Tesla, Inc. Service Bulletin		<h2>Reroute Main Front Body Harness</h2>	
SB-20-17-004 March 19, 2020			
Classification Campaign Bulletin		Section/Group 17 - Electrical	Mobile Service Cannot Perform
Model Year 2017 - 2019	Model Model X	Country/Region All	Version All
<small>The model(s) and model year(s) listed are a general approximation of the affected VIN list. Refer to the VIN/Bulletin Tracker or Customer/Vehicle profile to determine applicability of this bulletin for a particular vehicle.</small>

On certain Model X vehicles, the main front body harness might contact the RH front upper control arm.

Inspect the main front body harness near the RH front upper control arm, perform wire repairs (if necessary), and then reroute the harness.

Figure 3

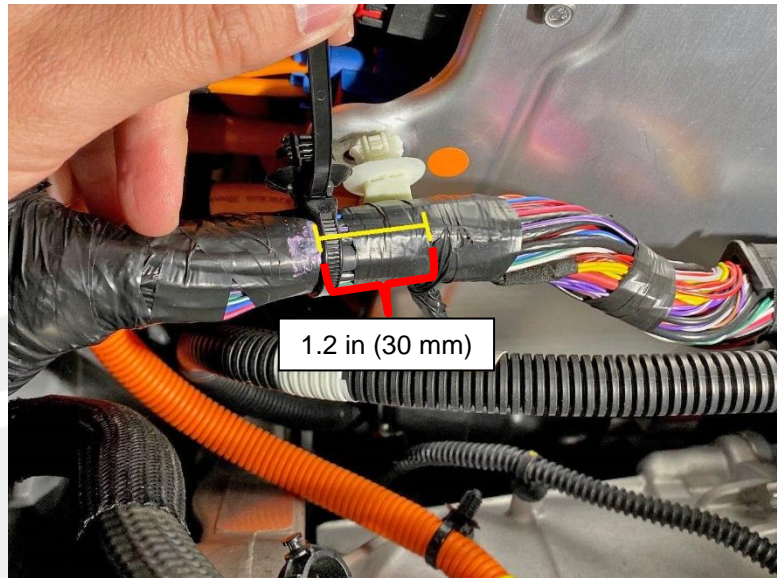
5. Install the new cable tie/clip onto the main front body harness 1.2 in (30 mm) right of the fir tree clip (Figure 3)

**NOTE:** The new cable tie secures the main front body harness further from the RH front upper control arm without putting tension on the wires.

Figure 6

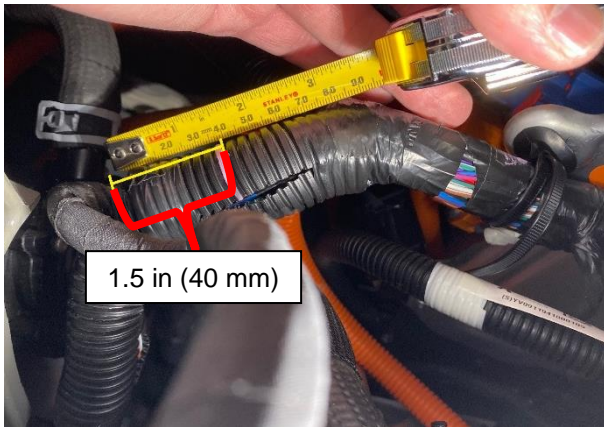
8. Relocate the breakout point of the front fusebox harness branch on the main front body harness. Use harness electrical abrasion tape to secure the front fusebox harness branch onto the main front body harness 1.5 in (40 mm) past the breakout point (Figures 6 and 7); this will add distance between the front fusebox harness and the front upper control arm.

Figure 8

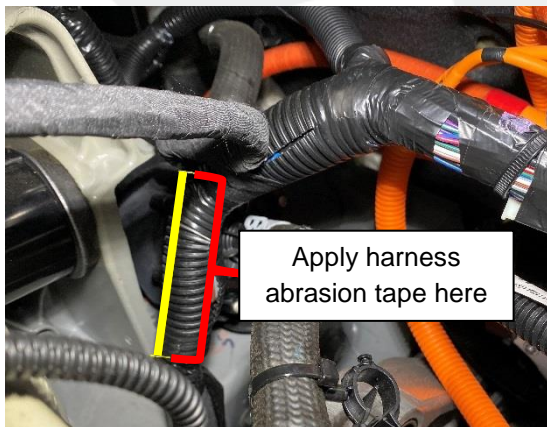
9. Apply abrasion tape around the harness branch to add protection to the harness (Figures 8 and 9).
